COMMITTEE OF ADJUSTMENT

NOTICE OF PUBLIC HEARING

APPLICATION NUMBER: GL/B-20:55

SUBJECT PROPERTY: 3051-3055 Homestead Dr., Glanbrook

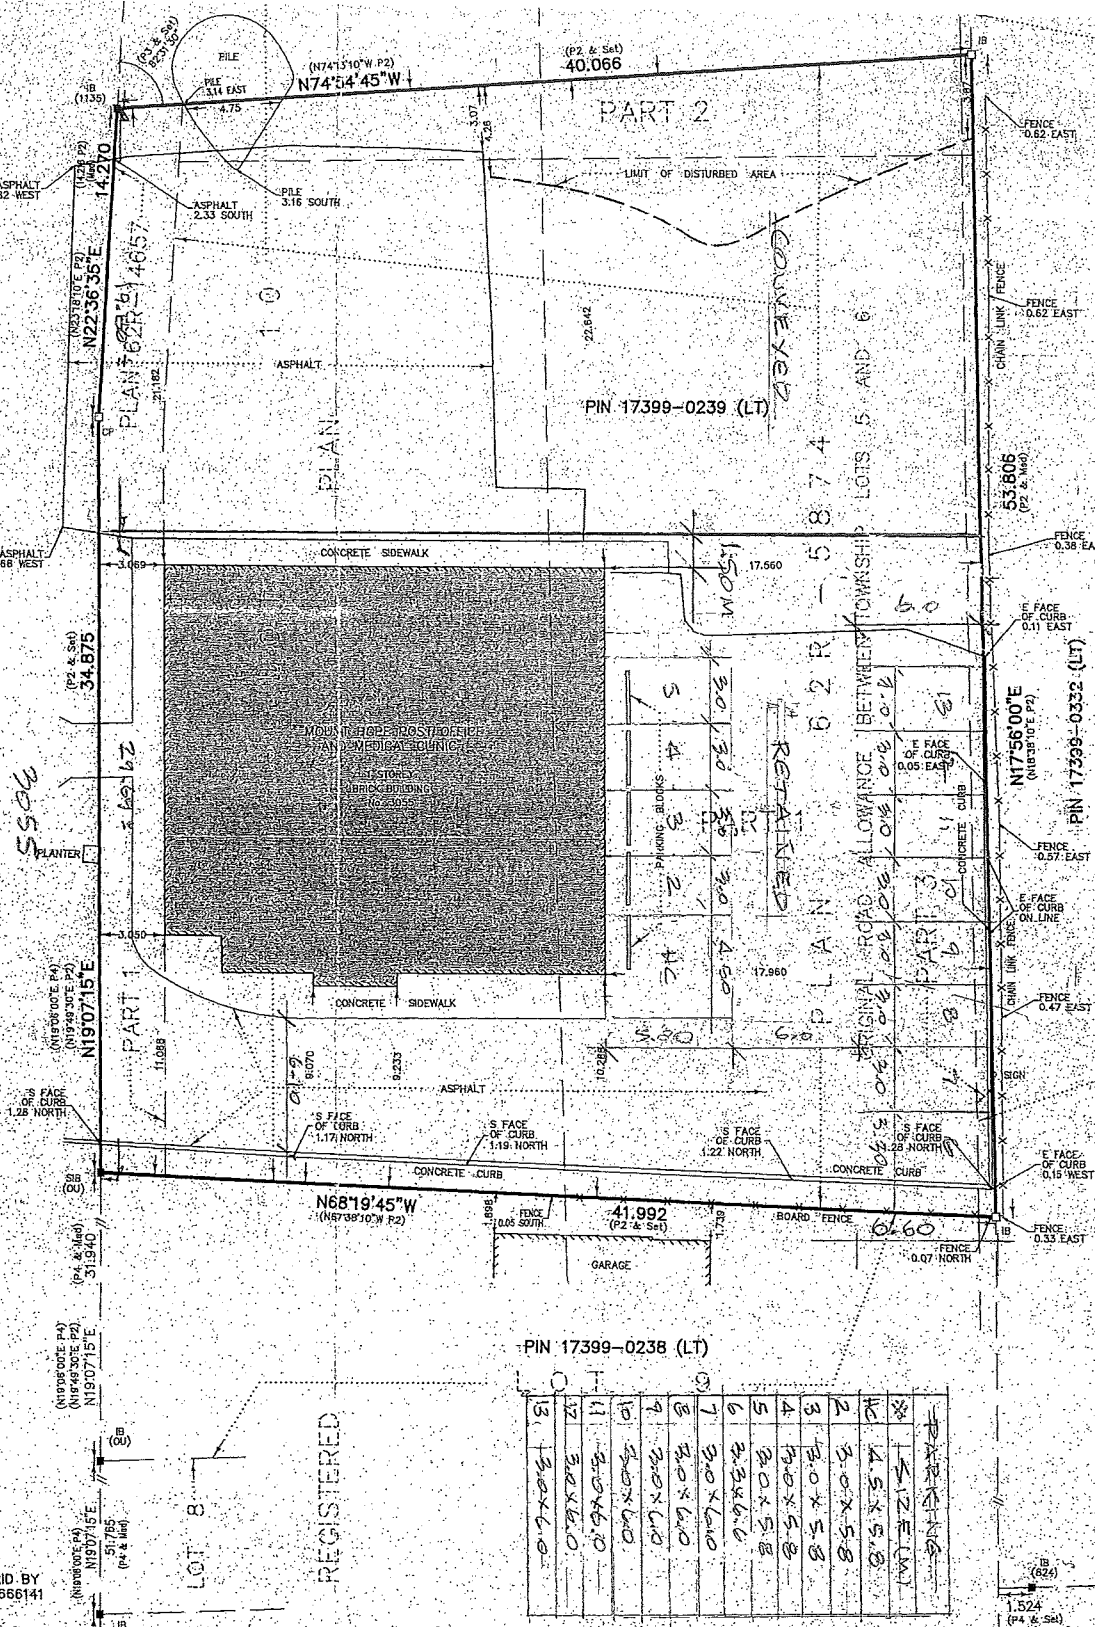
1. E-mail from Zivko Panovski removing condition #8
2. Revised survey/severance sketch moving the proposed property line to 1.5m off the existing north building face , proposed frontage and lot areas adjusted accordingly
3. Revised page 2 of the consent application
4. Applicable law review related to conditions 5,6 ,demonstrating compliance
5. E-mail from Victoria Brito confirming existing parking compliance. NB all zoning in compliance as per the ALR
6. Clearance of condition 4 (building code compliance) the letter says condition #6 which is a typo
7. Credit card payment form (\$190 recirculation fee)

In addition, the submitted plan shows a minor expansion of the existing parking area through the addition of three (3) new parking spaces north of the existing parking area on the retained lot. Please note that the establishment of the new parking spaces is subject to Site Plan Control; however, will be reviewed as part of this application.

Section 5	Required by By-law	Site Statistics/Show on plans	Compliance comment: Conforming non-conforming
	Any parking lot shall provide for ingress and egress of vehicles to and from a street in a forward motion only	Ingress and egress of vehicles to and from the street is in a forward motion	Conforms
Minimum Parking space size for parallel spaces <i>[Section 5.2 c) of Hamilton Zoning By-law 05-200]</i>	Each parallel parking space shall have a minimum width of 2.4 metres and a minimum length of 6.7 metres. End spaces which have a clear, unobstructed approach, shall have a minimum length of 5.5 metres.	Not proposed at this time	Not applicable
Surface materials for Parking Lots <i>[per Section 5.2 e) of the Hamilton Zoning By-law 05-200]]</i>	Parking lots shall be designed and maintained with stable surfaces such as asphalt, concrete or other hard-surfaced material.	Existing asphalt for the existing parking area. No details provided for the proposed three (3) new parking spaces.	Conforms Unable to determine compliance
